O'Reilly Auto Parts 6830 Coors Blvd NW

30-Day Temporary Certificate of Occupancy Transportation Development Final Inspection

Engineer's/Architect's Stamp dated 5-20-19 (E12D006G)

Checked April 27, 2018 Issue Date Site Plan for

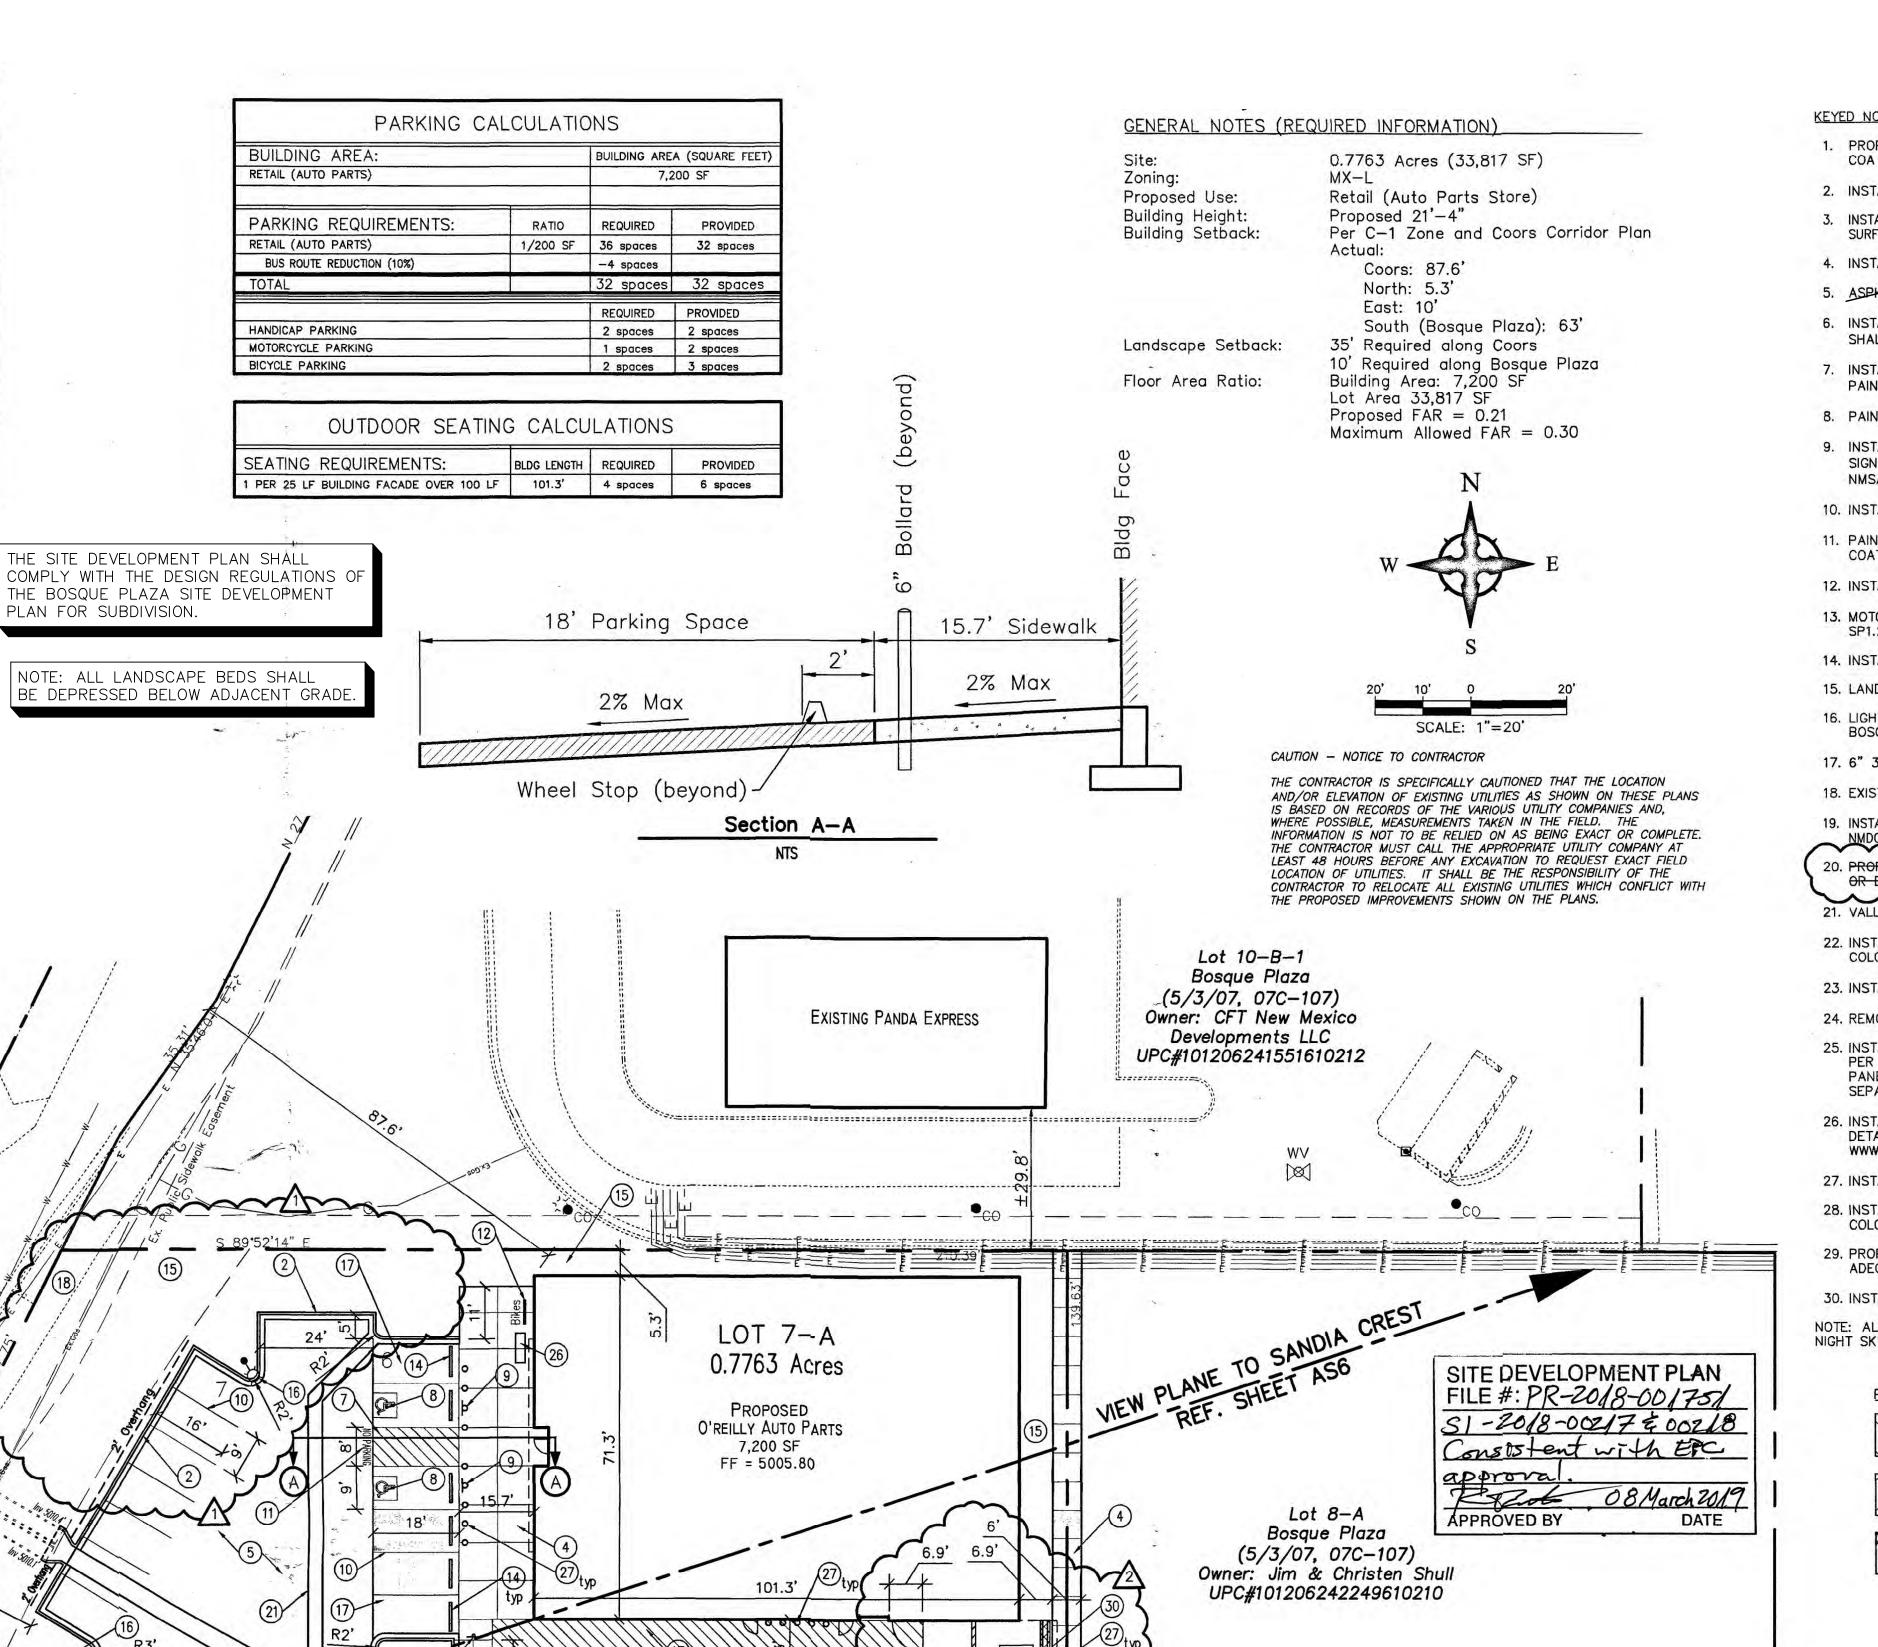
- 1. Please add missing Truncated Domes. (See approved plan)
- 2. Please add motorcycle signs.
- 3. Please paint COMPACT to the parking stalls as indicated on approved plan.

THE FOLLOWING ITEMS NEED TO BE CORRECTED PRIOR TO PERMANENT CO: - ADA ROUTE SIDEWALK TO BOSQUE PLAZA SHOULD BE CORRECTED TO A

- THE BENCH, TRASH CAN, AND TREE SHOULD BE ADDED ADJACENT TO

APPROVED SITE PLAN FOR SUBDIVISION. THE CORRECT POLES MUST

- COMPACT PARKING SPACES NEED TO BE PAINTED PER KEYED NOTE 22.

- CORRECT SIDEWALK JOINTS ON NEW SIDEWALK ALONG BOSQUE PLAZA.

- INSTALL THE DETECTABLE WARNING SURFACE PER KEYED NOTE 19.

- SECONDARY PEDESTRIAN ACCESS ON THE EAST SIDE OF THE SITE

- THE LIGHT POLES EXCEED THE MAXIMUM 16' HEIGHT PER THE

THE TRASH ENCLOSURE GATES NEED TO BE INSTALLED.

5% MAX RUNNING SLOPE (OR 8% WITH HANDRAILS).

THE ADA SIDEWALK TO BOSQUE PLAZA.

PLAN FOR SUBDIVISION.
